IDAP REPORT

Property:	20 Myee Avenue STRATHFIELD Lot 12 in DP 15955 DA2021.153
Proposal:	Demolition of existing structure, construction of a two (2) storey dwelling house with basement, outbuilding with bathroom and pool equipment storage, front fence, in-ground swimming pool and associated landscaping works.
Applicant:	ZTA Group
Owner:	R. Sibai
Date of lodgement:	6 July 2021
Notification period:	13 July 2021 – 29 July 2021
Submissions received:	1 (One)
Assessment officer:	L Gibson
Estimated cost of works:	\$1,078,001.00
Zoning:	R2 – Low Density Residential - SLEP 2012
Heritage:	N/A
Flood affected:	No
Is a Clause 4.6 Variation Proposed:	No
RECOMMENDATION OF OFFICER:	REFUSAL

Figure 13: Site Plan of subject site showing general extent of void space as highlighted in yellow.

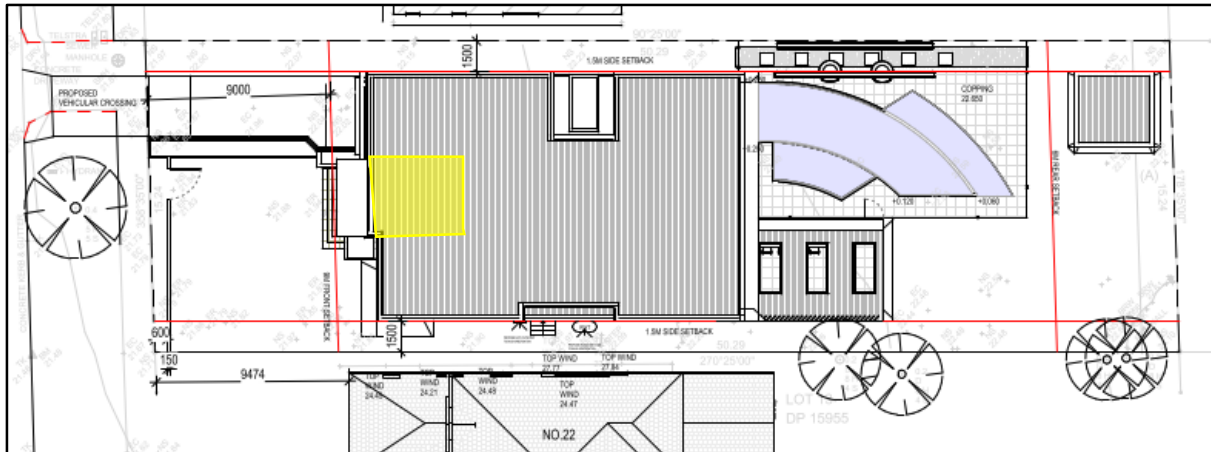
Applicable DCP Controls	DCP Controls	Development Proposal	Compliance/ Comment
Building Envelope			
Heights: Floor to ceiling heights:	3.0m	6.2m	No – refer to discussion below
Height to underside of eaves:	7.2m	6.95	Yes
Parapet height:	0.8m	0.5m	Yes
Overall height for flat roof dwelling:	7.8m	7.45m	
Basement height above NGL:	1.0m	550mm	
Number of Storeys/Levels:	2	2	
Setbacks: Front:	9m	9.3m	Yes
Side:	1.2m (min)	N: 1.5m	Yes
Side:	1.2m (min)	S: 1.5m	Yes
Combined Side Setback:	3.08m (20%)	3m	Yes
Rear:	6m	14.3m	Yes
Landscaping			
Landscaping/Deep soil Provisions:	43% (331.7m ²)	28.22% (217.7m ²) based on the original landscape plan submitted to Council.	No – based on information provided to Council, it appears deep soil zone is insufficient.
Fencing

- a) The proposal results in unacceptable void spaces providing a floor to ceiling height of 6.2m contrary to Section 4.2.2 of Part A of the SDCDP 2005. This results in additional and unnecessary bulk and scale to the development which further increases overshadowing impacts to the southern adjoining property (Section 4.15(a)(i) of the *Environmental Planning and Assessment Act 1979*).

Figure 14: Proposed Landscape Plan

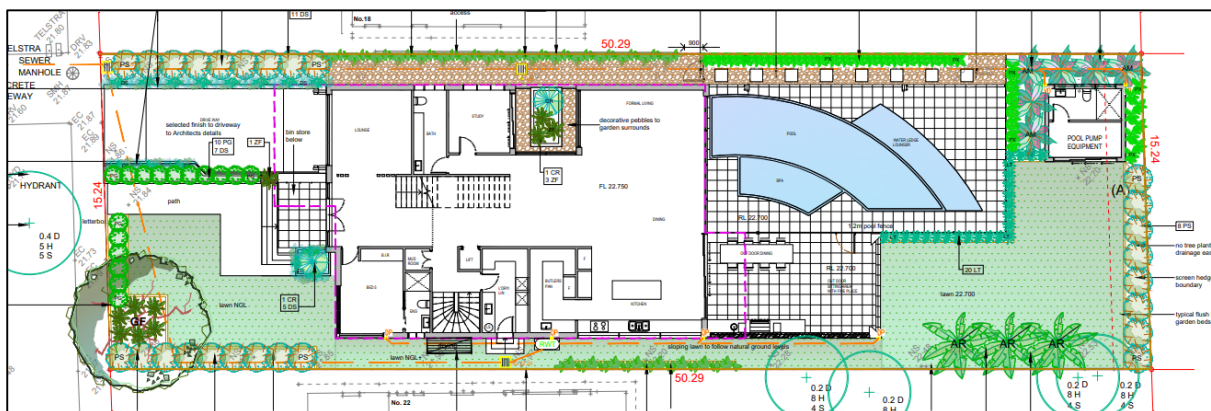
The proposal is required to provide a minimum 43% (331.7m²) deep soil zone as per Section 5 of the SCDPC 2005. Based on the original landscape plan submitted as part of the application to Council, a minimum 28.22% (217.7m²) deep soil zone was proposed (refer to Figure 14 below). The plan presents a significant departure from the minimum requirements and was requested to be amended as part of the first deferral letter sent to the applicant.

Figure 15: Revised draft landscape calculation Plan.

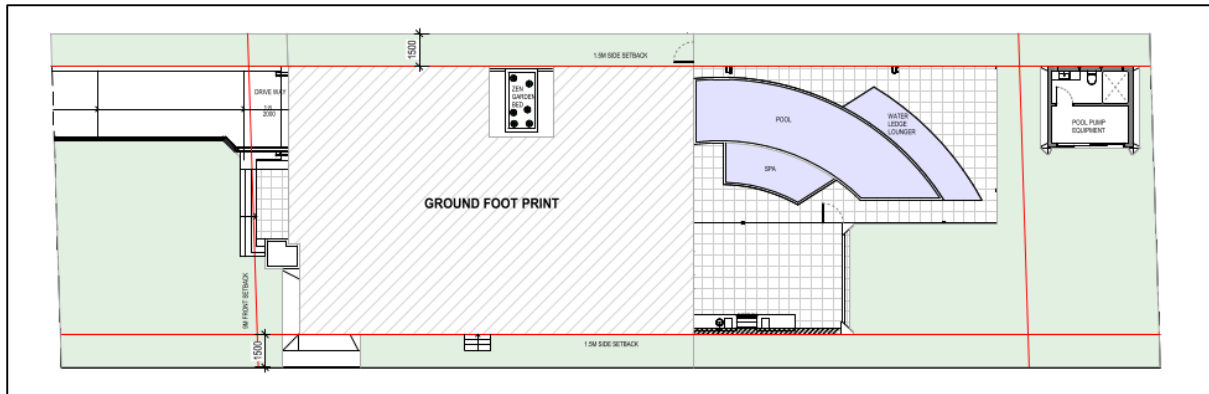
The applicant submitted a revised draft landscape calculation plan during the assessment process (refer to Figures 15 below). The revised plan shows little change made to the original plan submitted to Council. The plan has also included areas of 1.5m or less as deep soil zone which is contrary to the definition of deep soil zone. Deep soil zone must be more than 1.5m in order to be included as such. It is further noted that the plan fails to include a pedestrian walkway from the front boundary to the front entrance which would further reduce deep soil zone through the site.

The plan fails to comply with the minimum numeric landscaping requirements for the site. The site is located within a generous and relatively unconstrained parcel of land and provides ample opportunity to embellish the site with deep soil zone suitable to the scale of the development.

Accordingly, compliance with the minimum landscaping requirements should be achieved without detriment to the overall design of the dwelling. This has been included as a reason for refusal.

Figure 17: Shadow Diagram showing extent of overshadowing at 9am 21st June

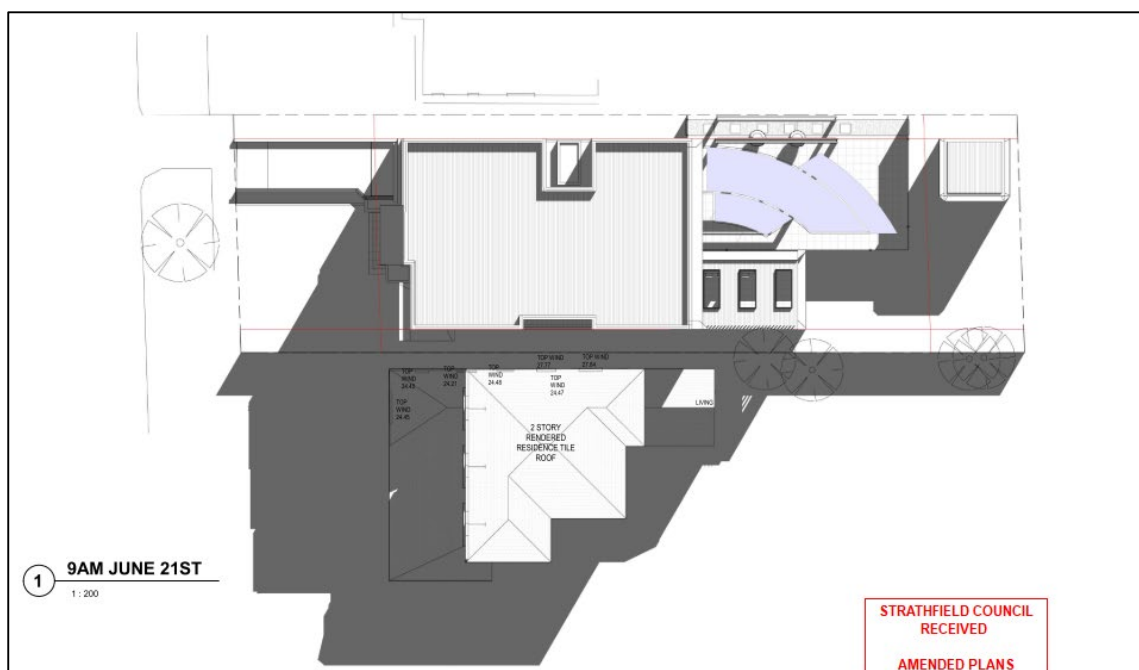
The figures above demonstrate that at 9am the proposed development casts a shadow over the northern wall of the southern adjoining dwelling as well as portions of the rear eastern elevation. At 12pm, the shadow moves east and continues to cast a shadow along the majority of the northern wall of the dwelling. By 3pm, the shadow moves further east, casting a shadow over the majority of the rear yard of the property.

Figure 20: Shadow on elevation plans depicting extent of overshadowing to southern adjoining property.

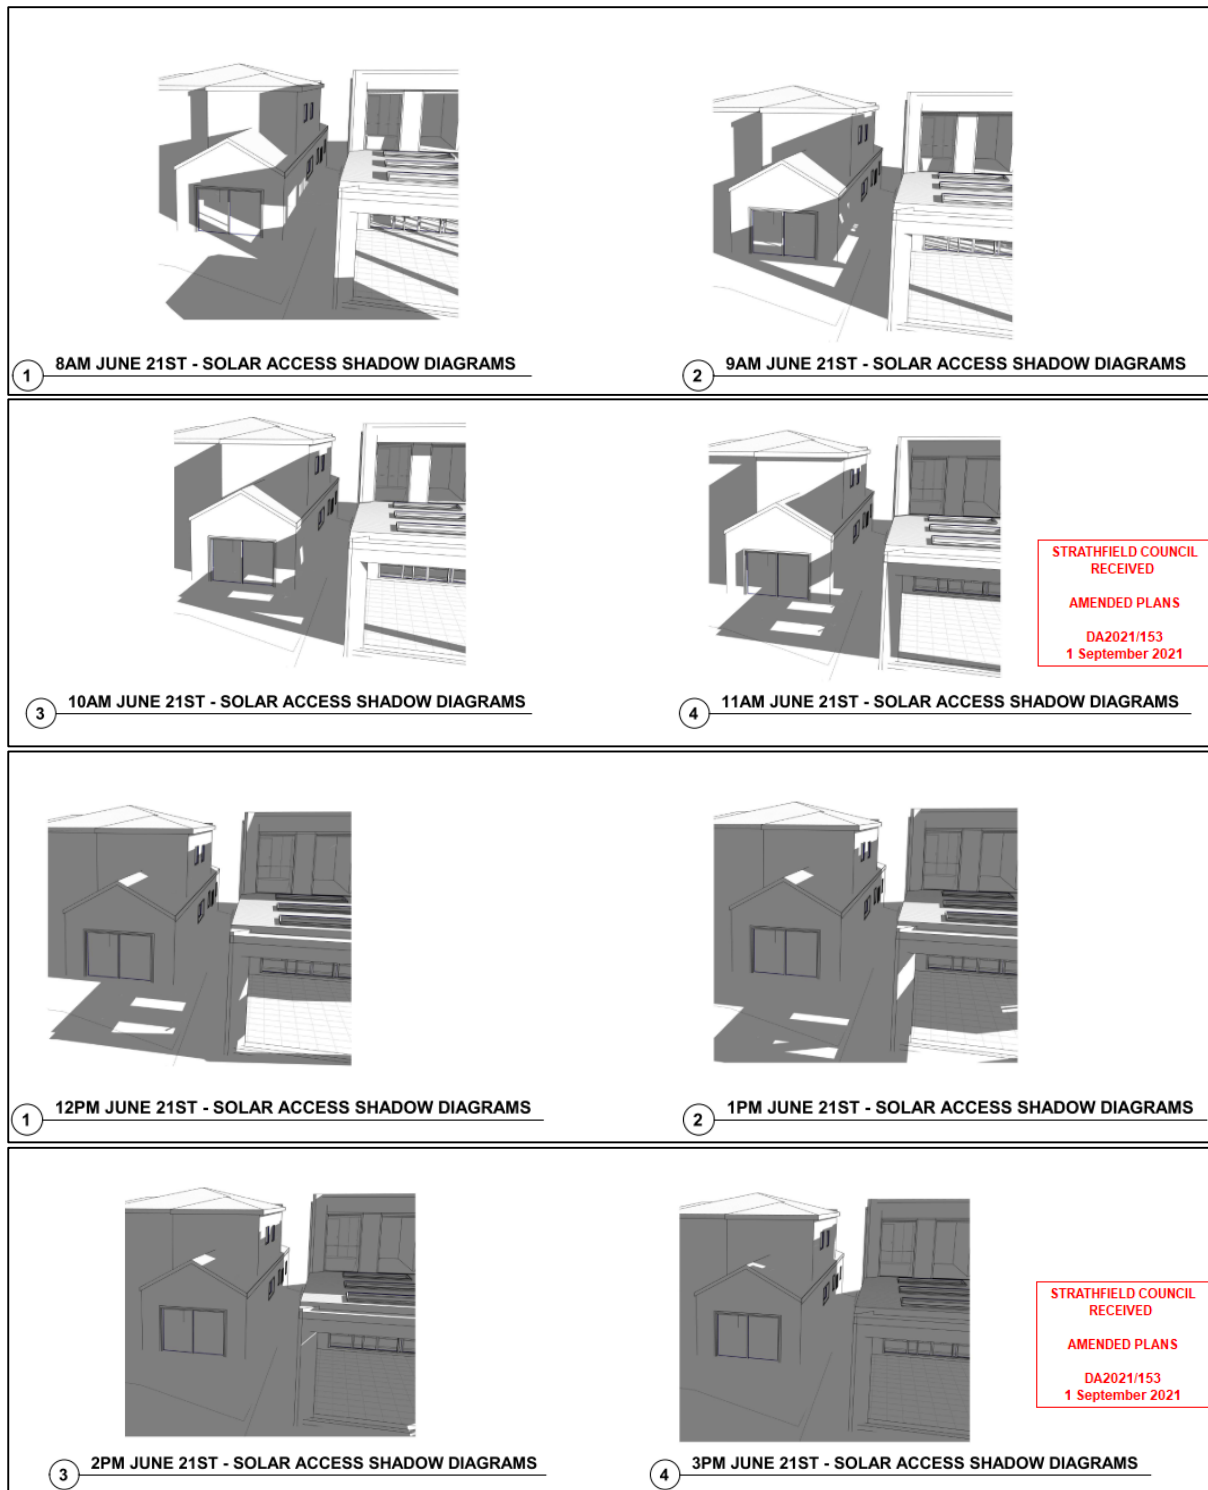
The shadow on elevation diagrams further demonstrate that the proposal overshadows the large bifold door upon the rear southern elevation of the dwelling (refer to figures 20 and 21 below). This room (pertaining to the kitchen), will only receive some solar access at 8am only. As clarified by the objector, the kitchen does not have any northern oriented windows to enable any solar access to be received and thus relies upon the eastern opening for some natural light.

Figure 22: Revised roof plan depicting small cut out on the southern side elevation

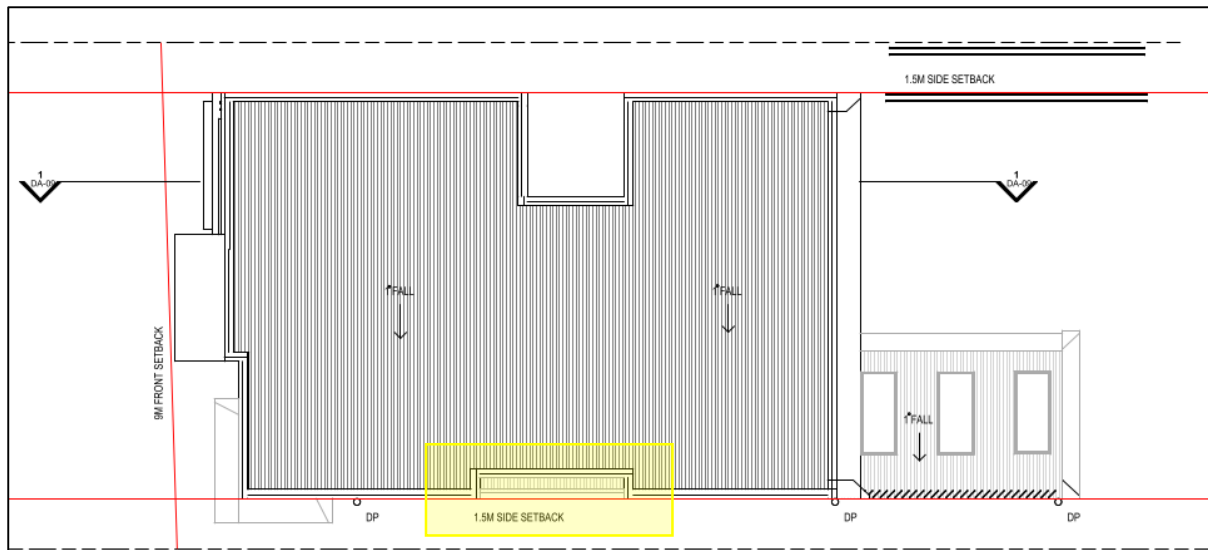
A further request was made, via a third deferral letter, to the Applicant to revise the design so to minimise overshadowing impacts to the southern adjoining property. Specifically, the following design changes were requested to be considered:

- Relocate the zen garden to the southern side of the dwelling;
- Increasing the front setback to the southern portion of the façade;
- Relocating the rear alfresco area to the northern portion of the dwelling;
- Reducing the overall building height and length of building footprint where possible.

The revised set of plans submitted to Council demonstrated only a slight reduction in the overall building height and a small cut out proposed to a portion of the southern elevation wall on the first floor. These changes have not resulted in any noticeable improvement to overshadowing impacts to the southern adjoining property (refer to figure 22 below).
